REPORT SUMMARY MINOR VARIANCE APPLICATION FILE NUMBER A071/25

Report Date: August 15, 2025

CITY WARD #:	5
GITT WARD #:	
APPLICANT:	Wahe Wartan & Noor Madhat
AGENT:	Rebecca Muise (David Small Designs)
PROPERTY:	20 Helen Avenue, Thornhill
ZONING DESIGNATION:	See below.
VAUGHAN OFFICIAL PLAN (2010) DESIGNATION:	Vaughan Official Plan 2010 ('VOP 2010'): "Low Rise Residential"
RELATED DEVELOPMENT APPLICATIONS:	N/A
PURPOSE OF APPLICATION:	Relief from the Zoning By-law is being requested to permit the construction of a proposed dwelling.

VAUGHAN Minor Variance Application A071/25

Site Plan

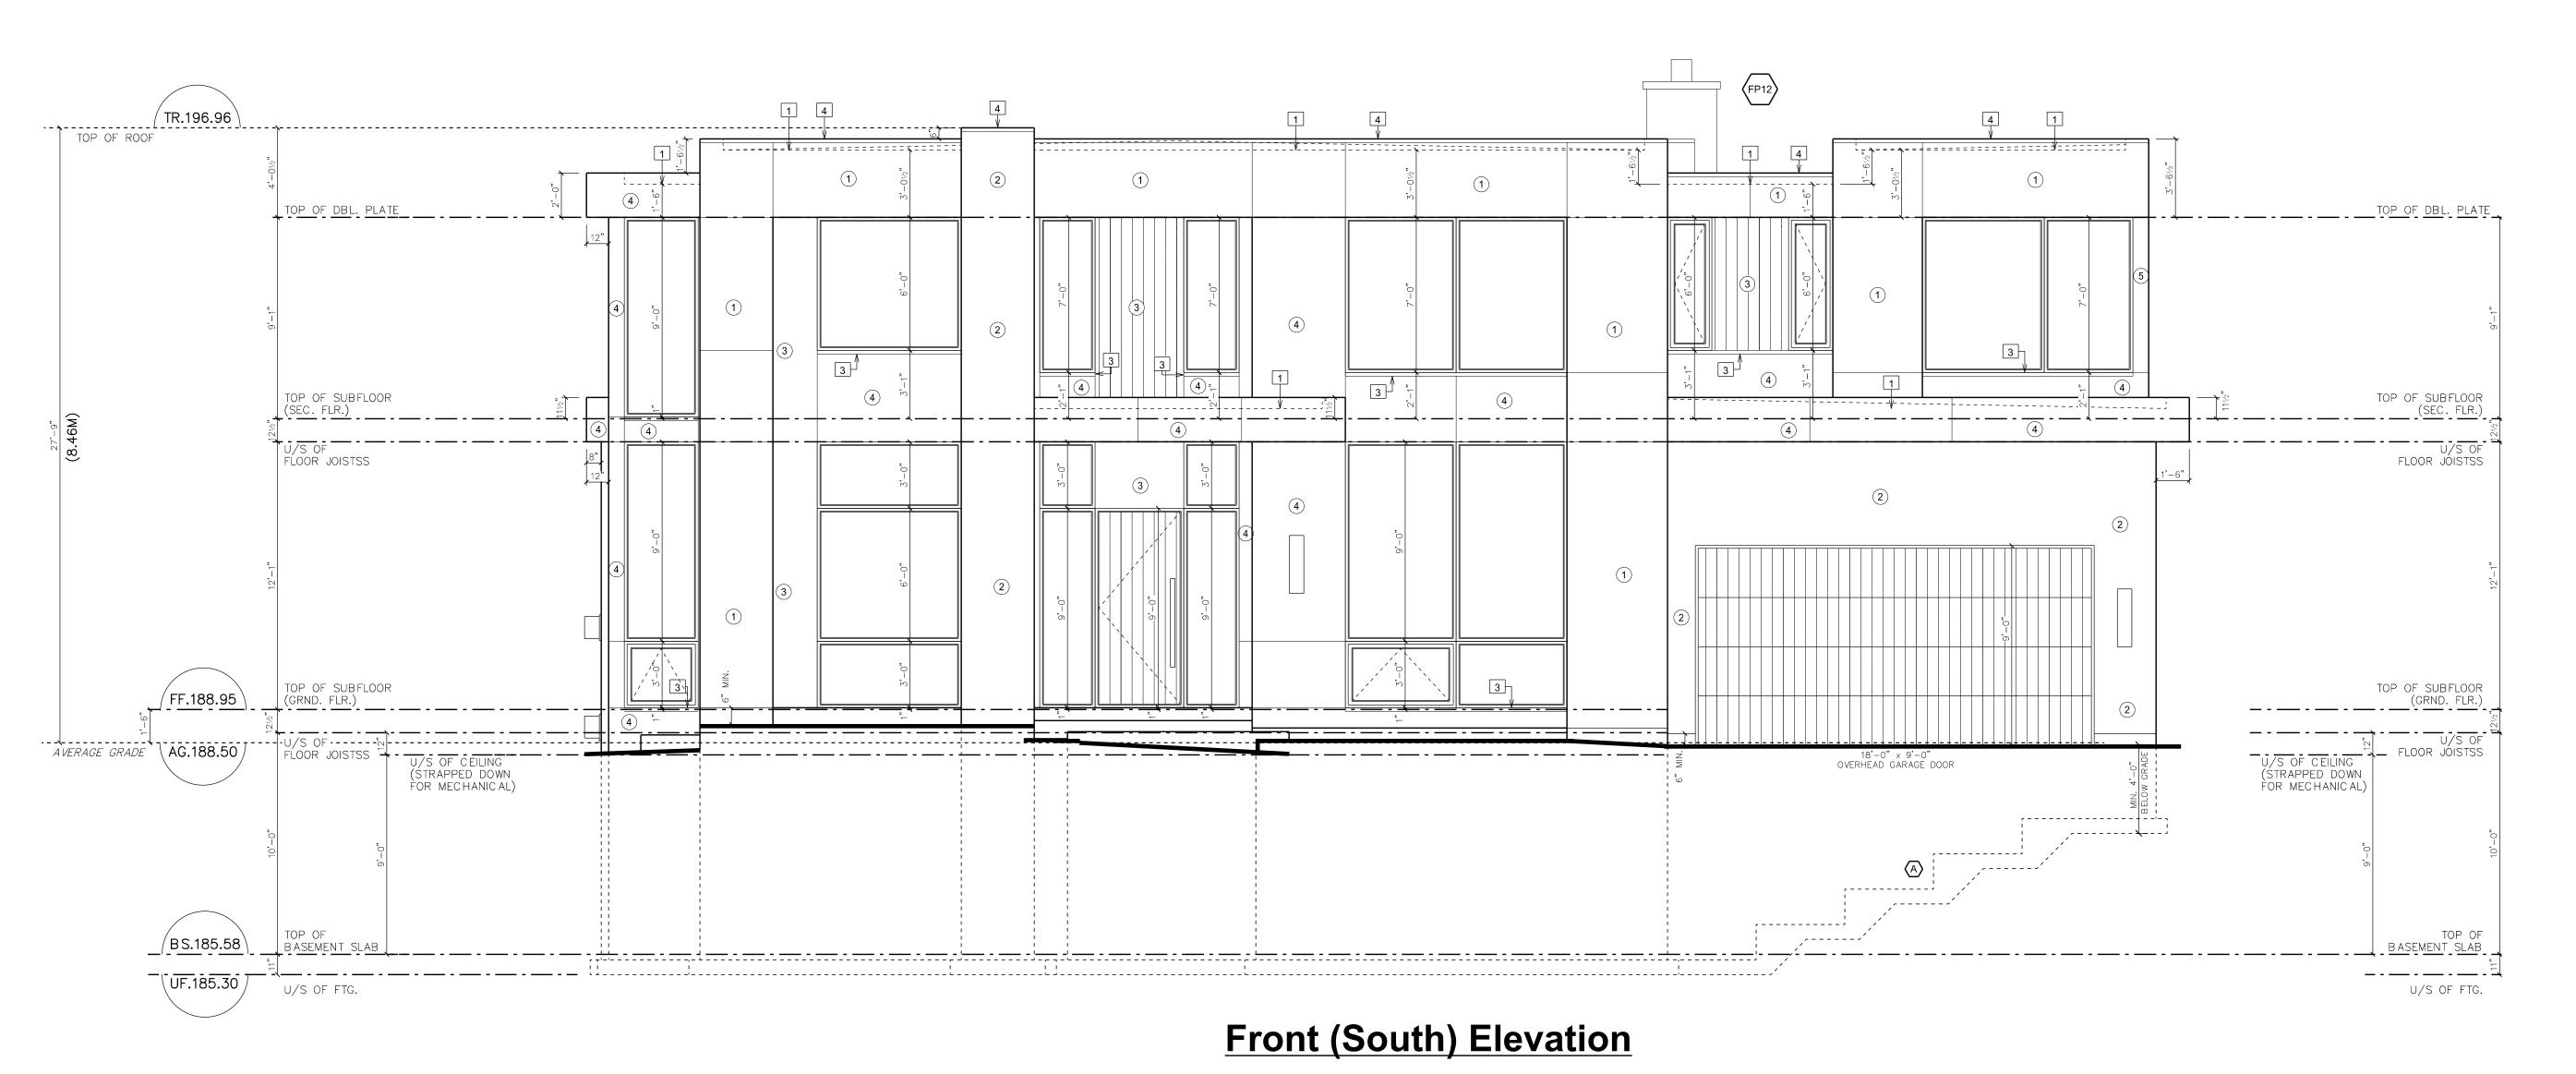
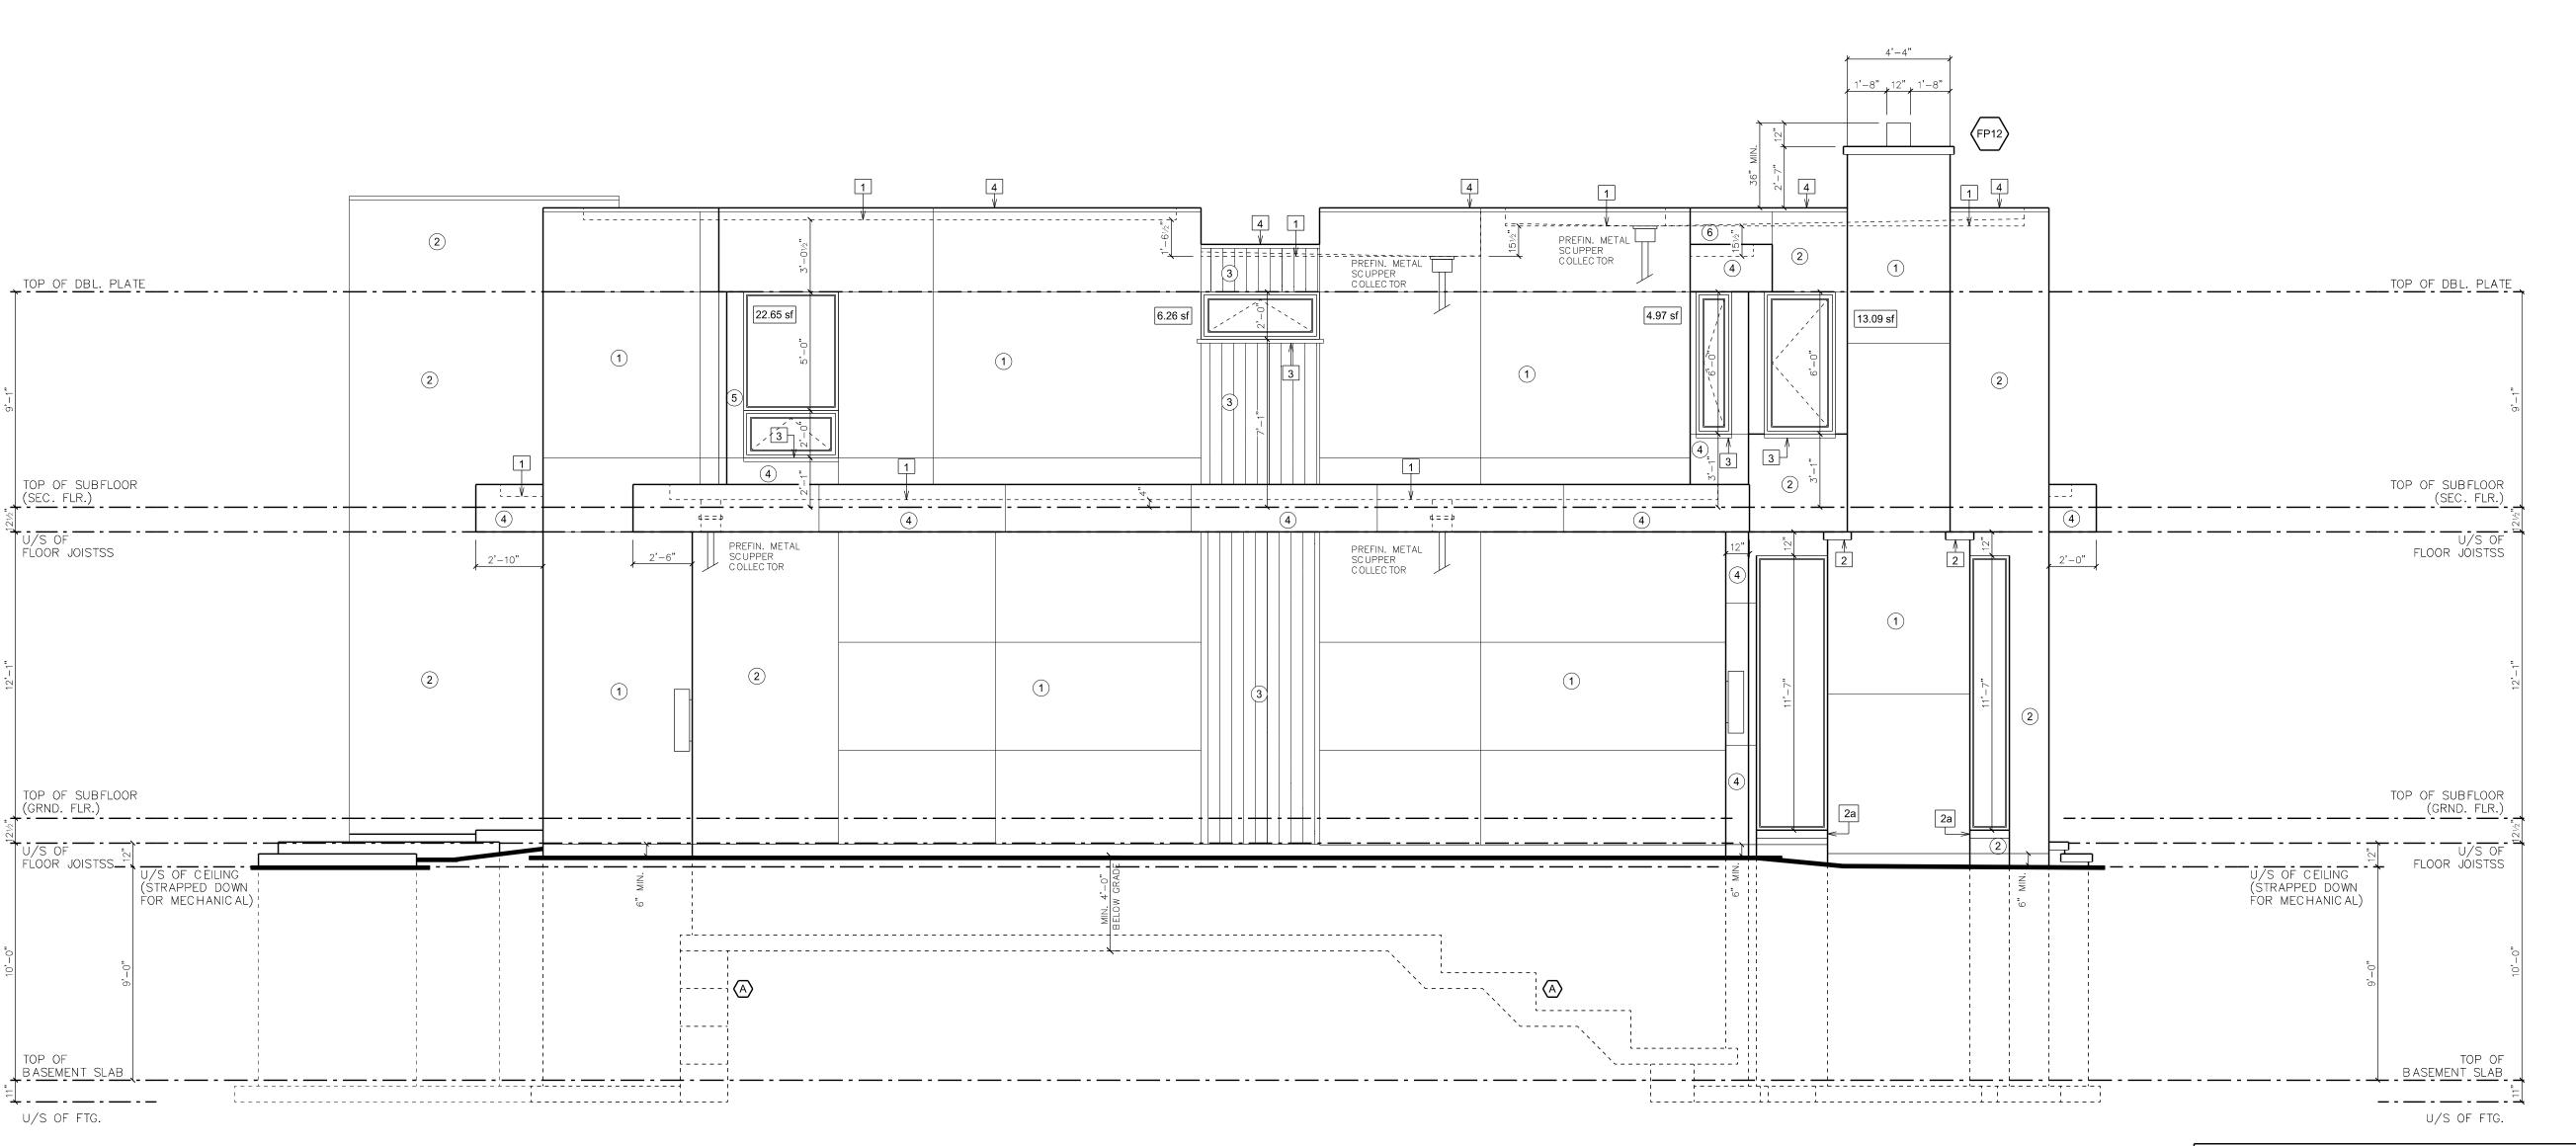
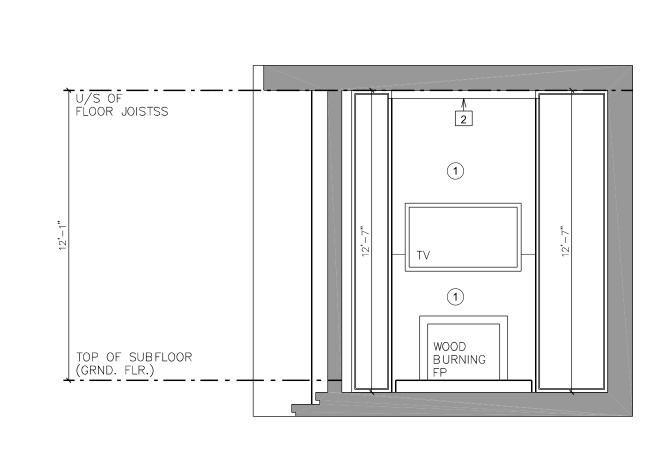
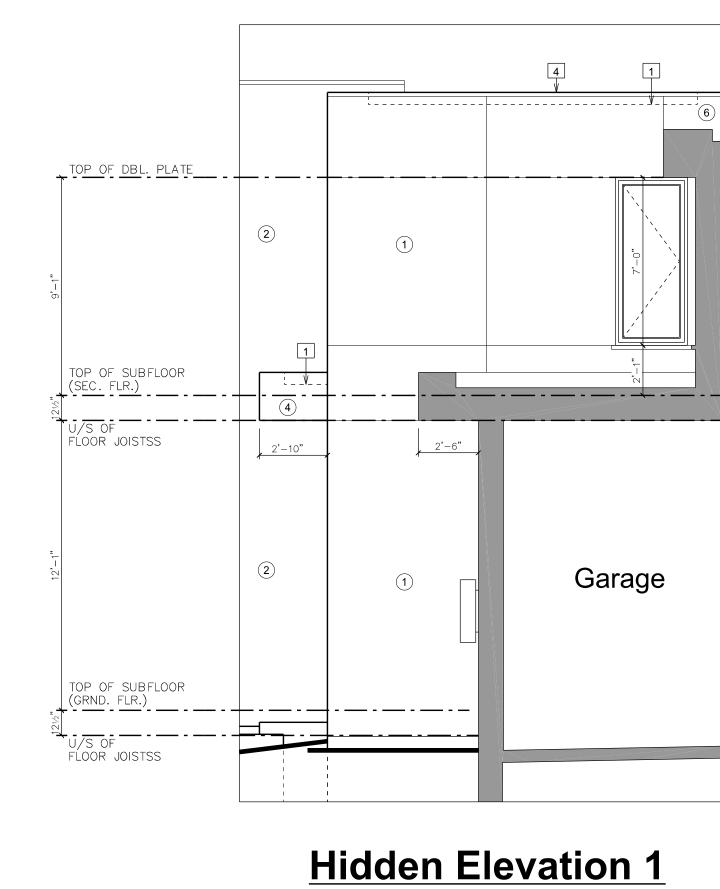
The Development and Parks Planning Department has no objections to Variance 1 to permit a total lot coverage of 25.1%. The proposed 25.1% consists of 22.9% for the enclosed portion of the dwelling, 0.3% for the proposed front porch, and 1.9% for the proposed rear yard cabana.

The Development and Parks Planning Department has no objections to Variance 2 to reduce the minimum front yard setback of the proposed dwelling from 13.62 m to 10.92 m. The property is subject to the Established Neighbourhood "(EN)" provisions of the Zoning By-law, which require newly proposed dwellings to respect the setbacks of the existing dwelling on the lot. The minimum setback of 10.92 m is observed at the southwest corner of the proposed dwelling, while the majority of the dwelling's front wall is proposed to be setback approximately 13 m from the front lot line. The remaining front yard is sufficient to provide for a driveway and landscaping opportunities. The proposed front yard setback reduction is minor in nature and is not anticipated to impose massing impacts on the public realm.

The Development and Parks Planning Department has no objections to Variance 3 to permit a reduced interior side yard setback for the proposed cabana in the rear yard. The proposed cabana has a flat roof and is compliant with maximum lot coverage and height provisions. The majority of the cabana's floor area is unenclosed. The proposed 1.5 m setback is sufficient for access and maintenance. The cabana has a modest mass and the proposed setback reduction is not anticipated to incur any negative impacts on the adjacent neighbour.
